DEWBERRY 12
COMPLIANCE PACKAGE 'A4'

Greenpark.
project name
RUSSELL GARDENS PH.2
municipality
WATERDOWN, ON.
date
JUNE 2017
checked by
scale
3/16" = 1'-0"

CORNER
DEWBERRY 12
project no.
16036
drawing no.
A1
16036-DEWBERRY-12
JUN 26 2018 - 1203 29

BASEMENT PLAN ELEVATION '1'

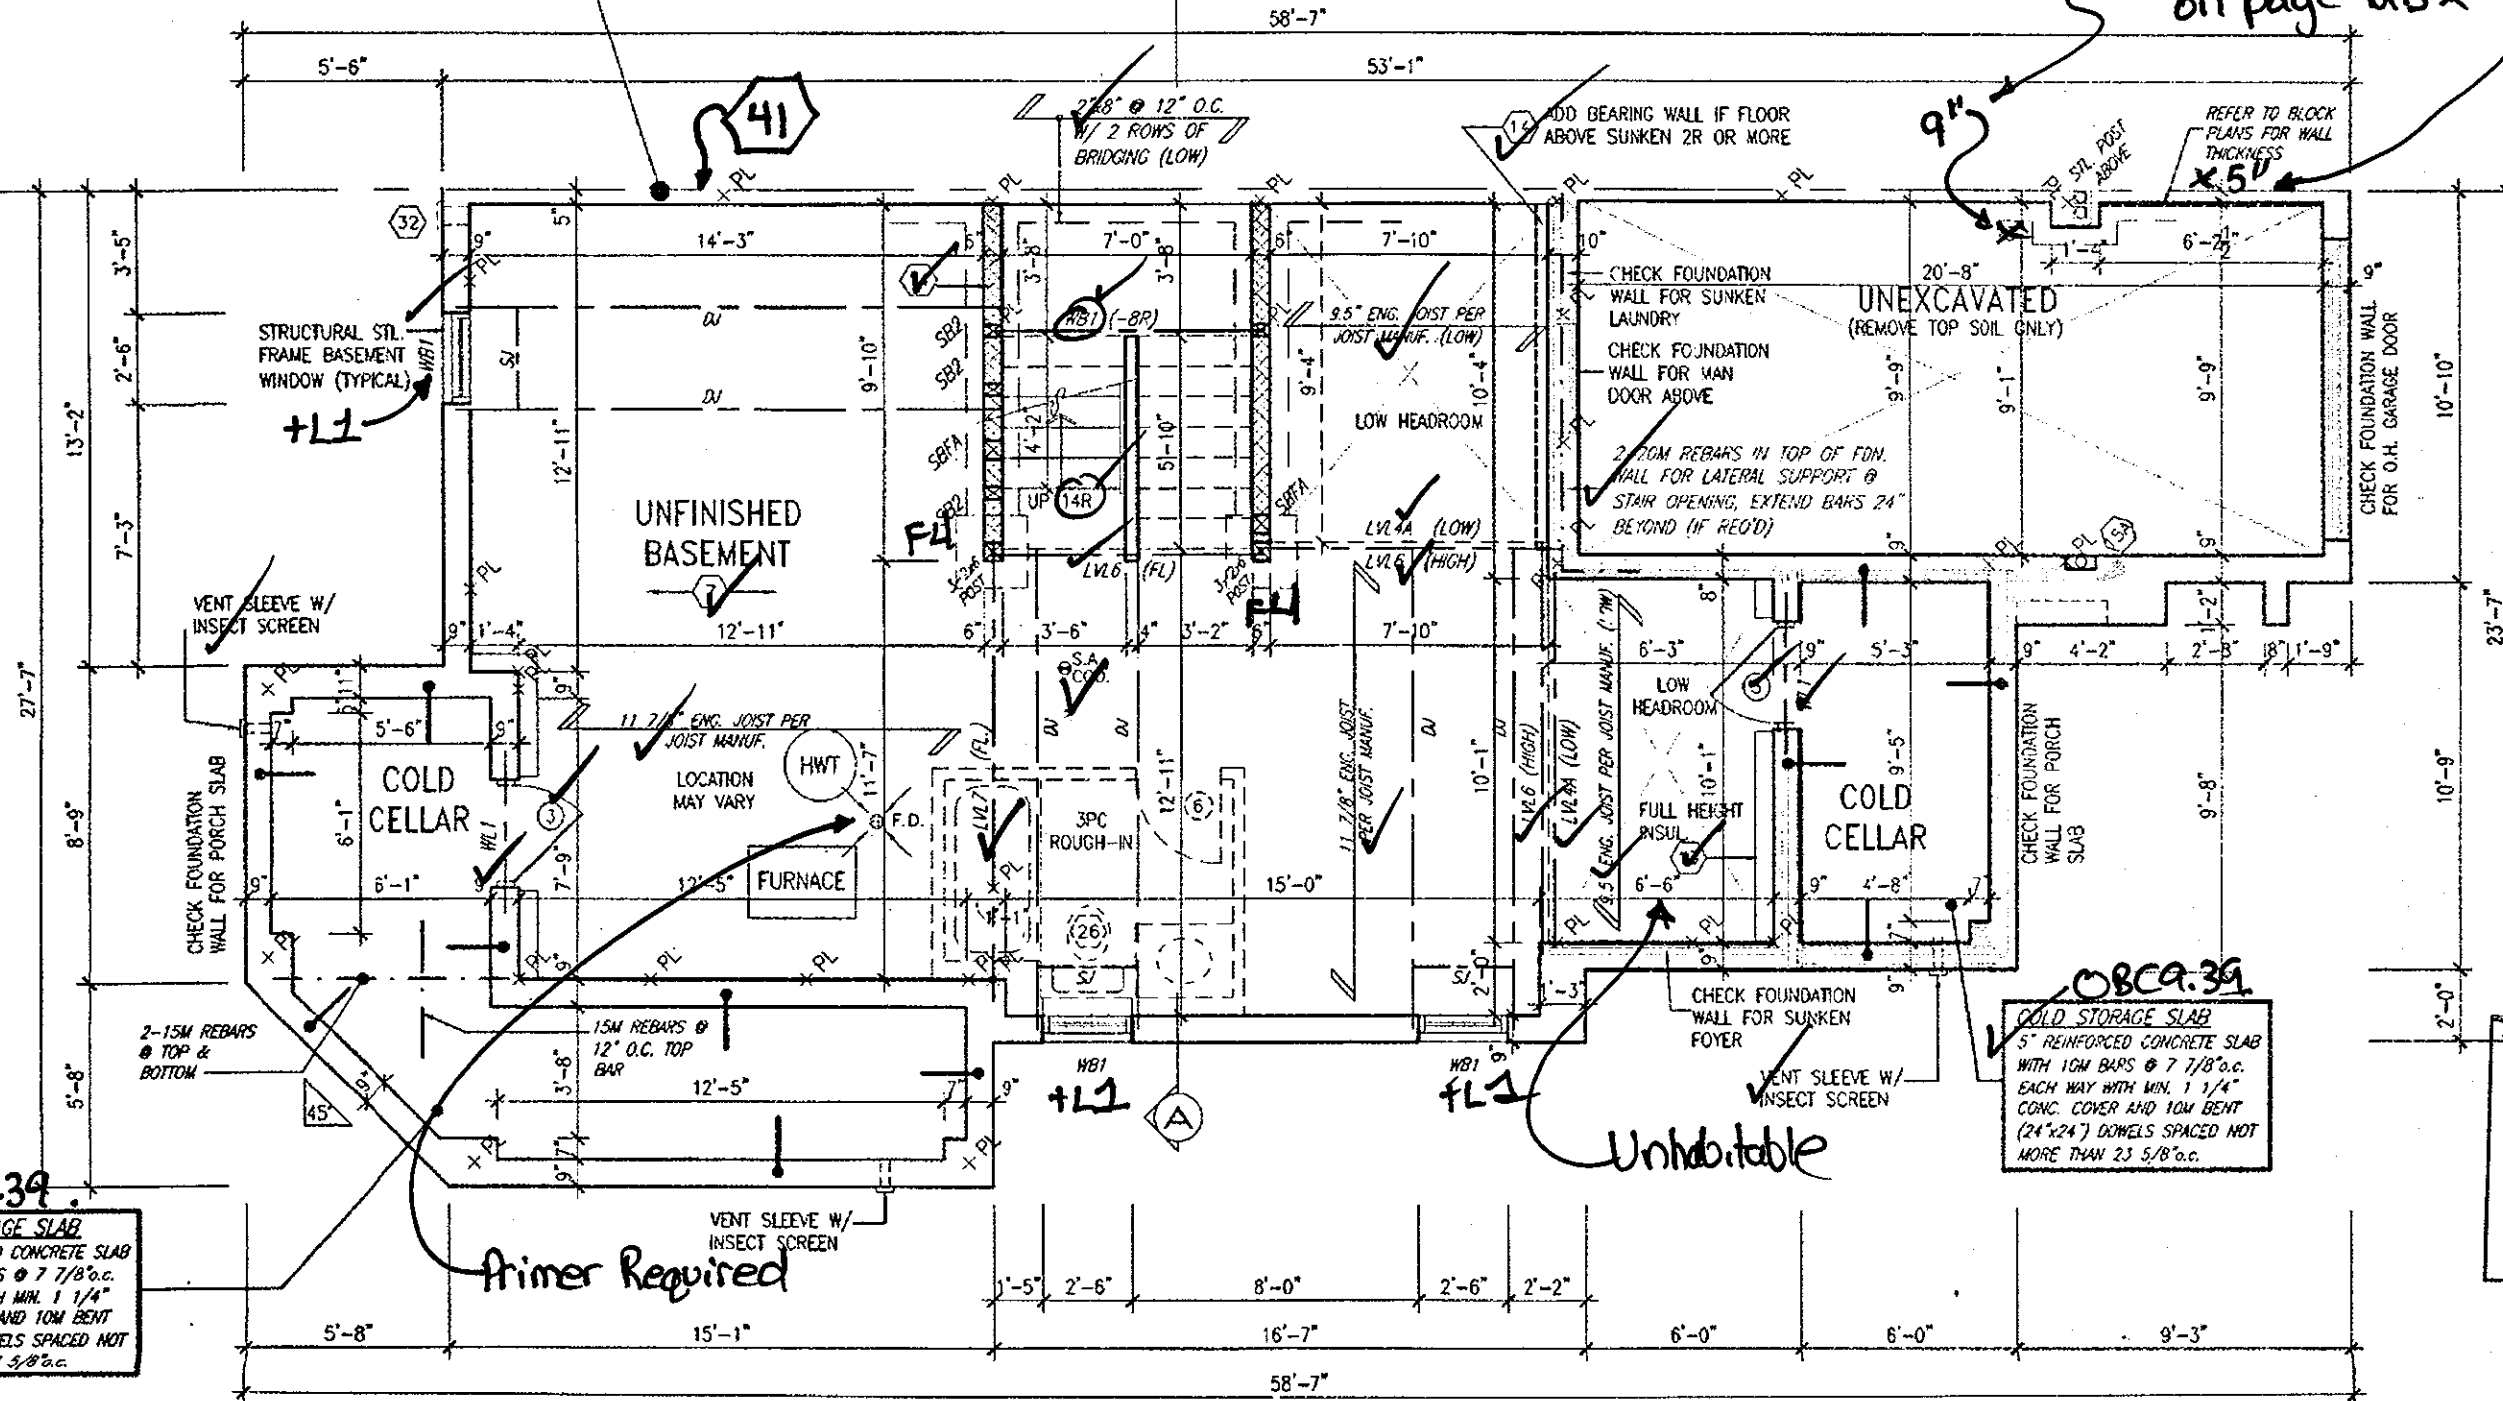
*As per updated details
on page 12B*

ENTRY LEVEL PLAN ELEVATION '1'

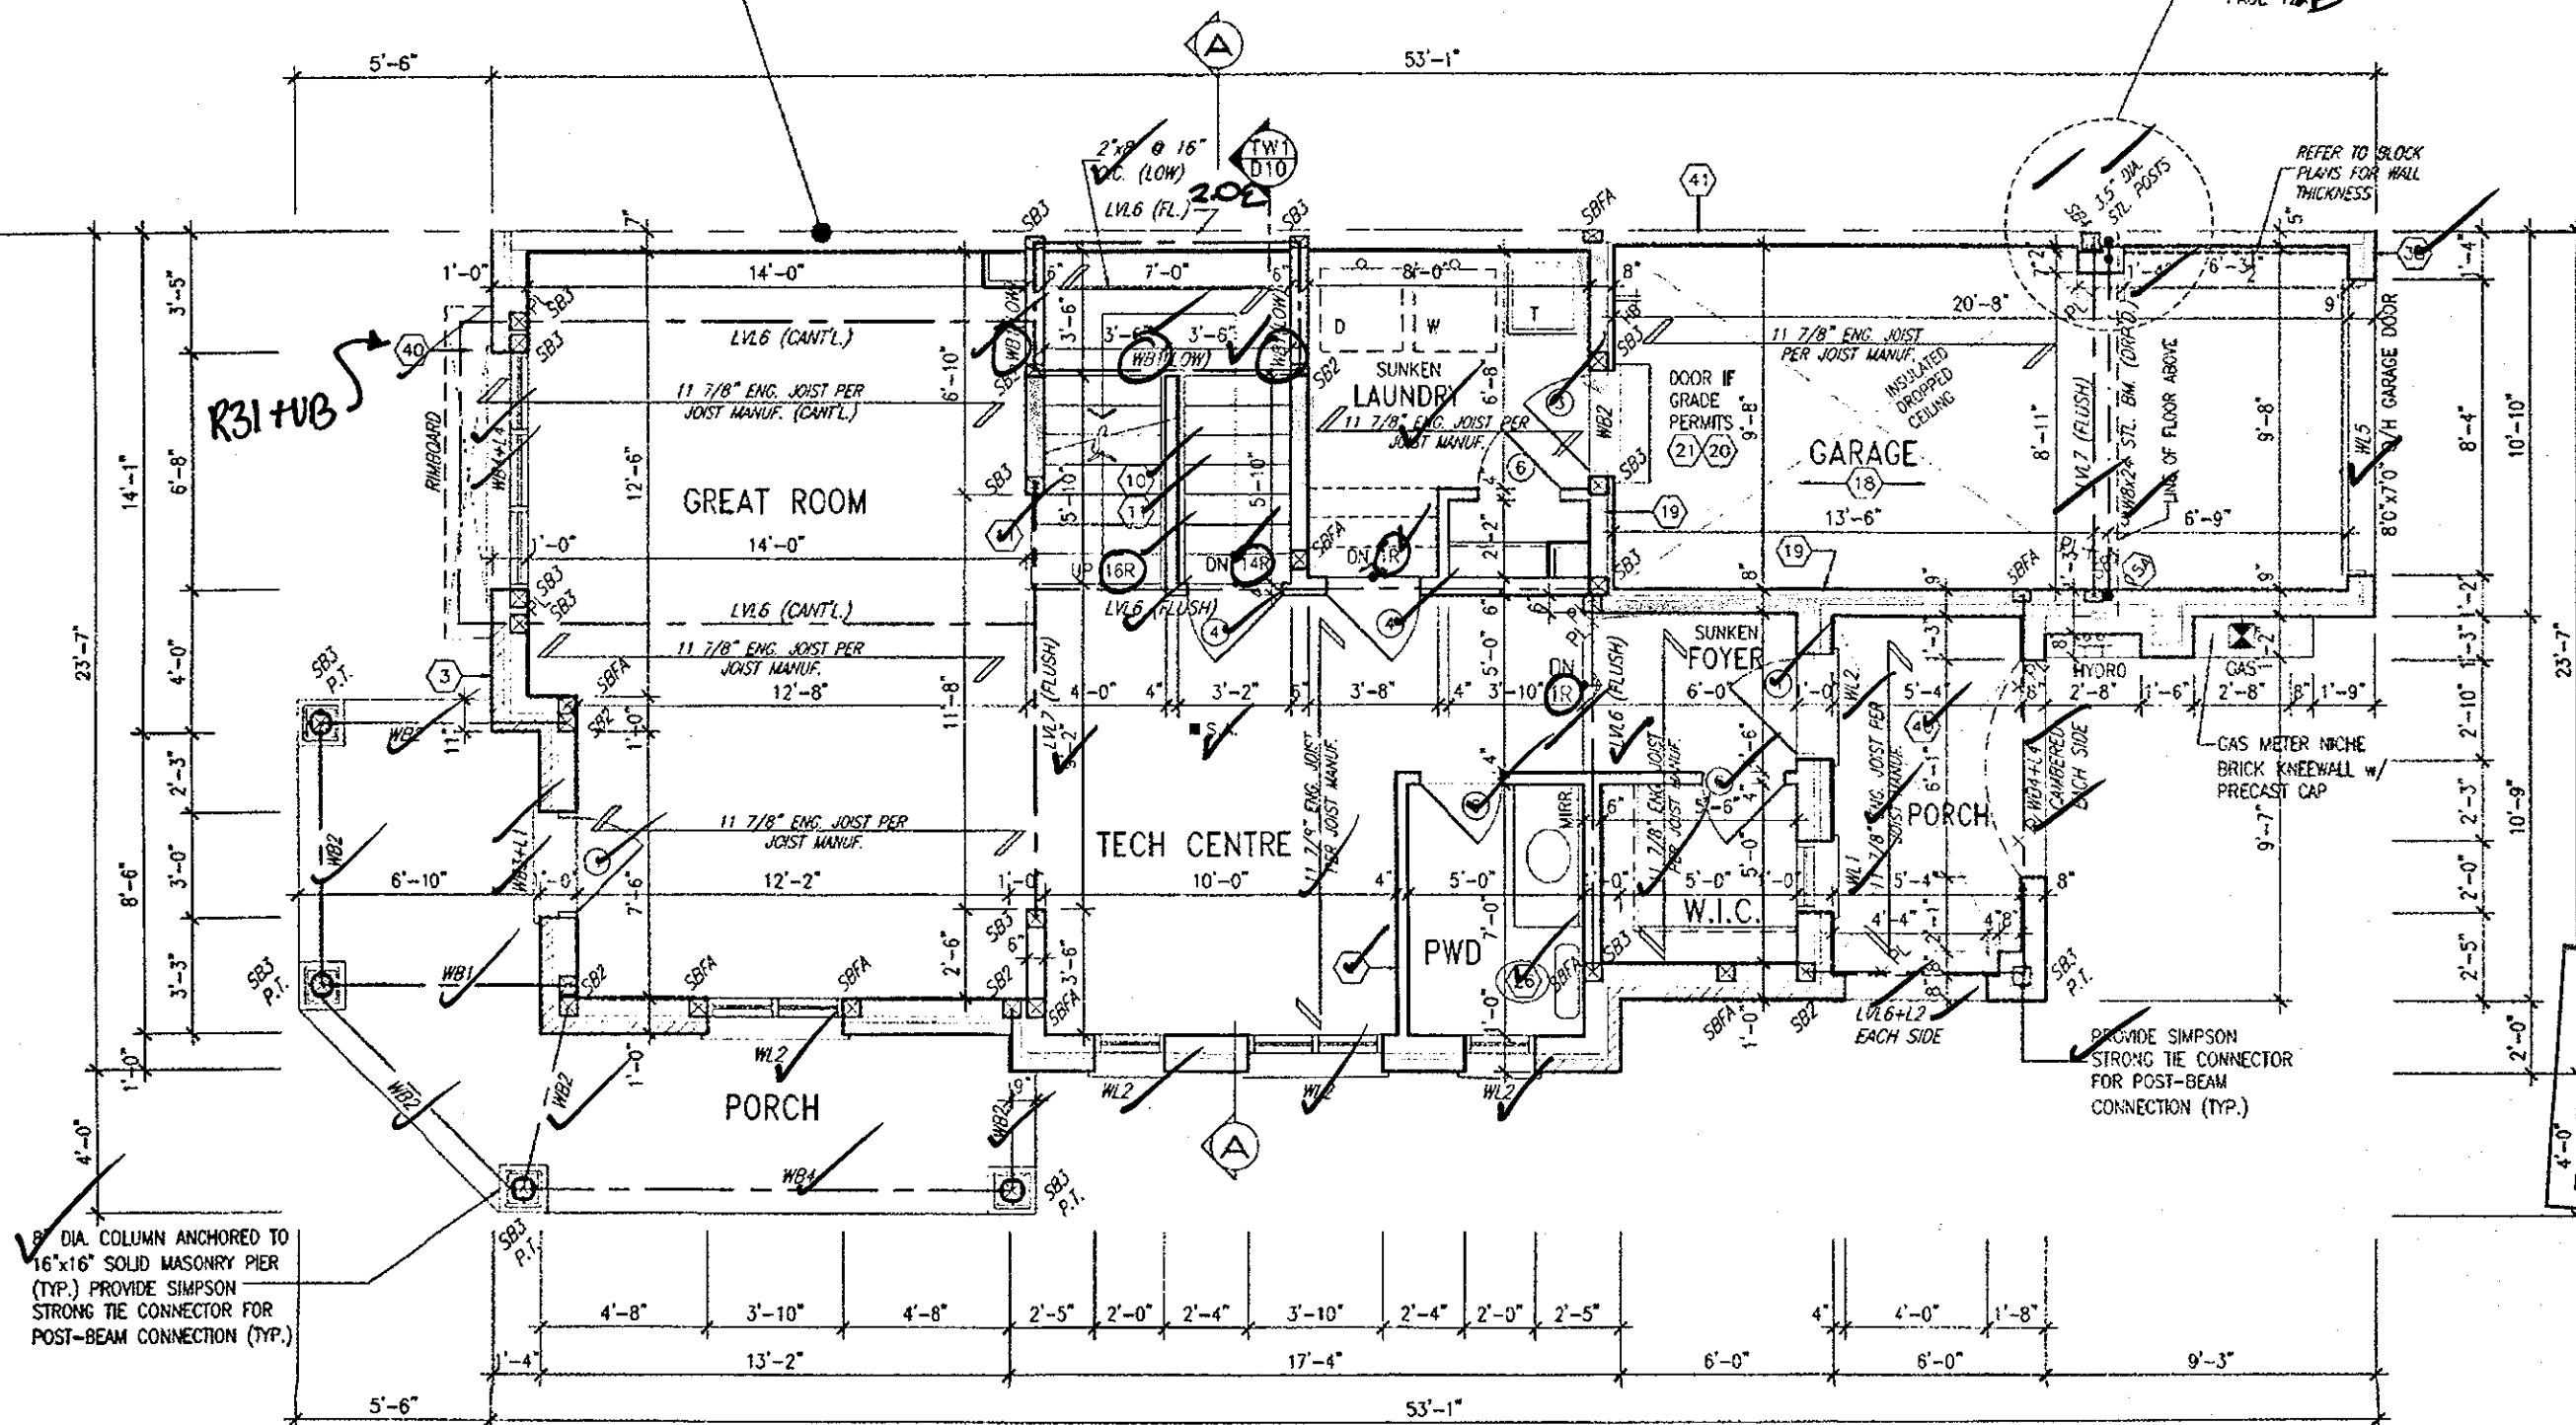
REFER TO DETAIL
PAGE 12 **B**
